# APPLICATION

PERCOLATION TESTING

SUBDIVISION Warfields Grant LOT NO. 188

A-42612

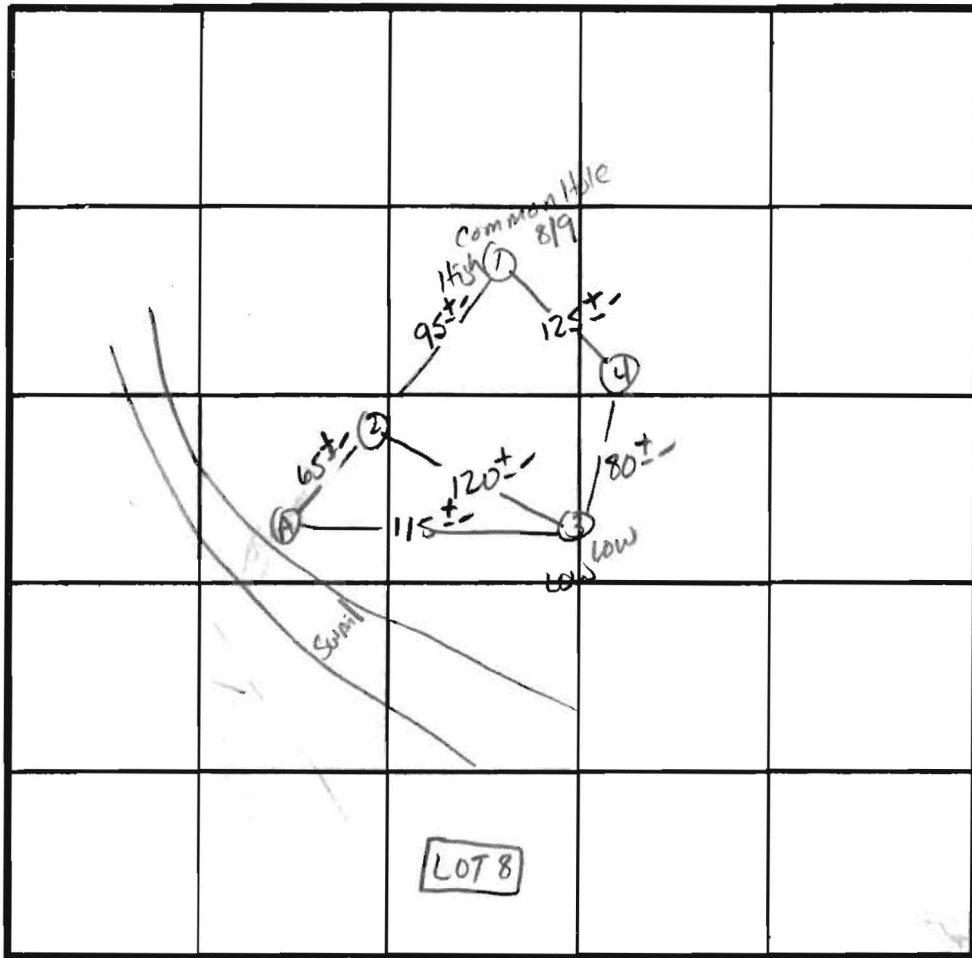
REASONS FOR REJECTION OR HOLDING 10/27/88 Perc Satisfactory - Providing Area can be moved higher than hole four (4) w/ 10R & w/ suitable house level size. Hold for PERC. sab

REMARKS Holes Diff Than PLAT - Shallow Syst only - move Perc Area Above Hole # 3 to Hole 4+ Above to Pass Lot's SAG
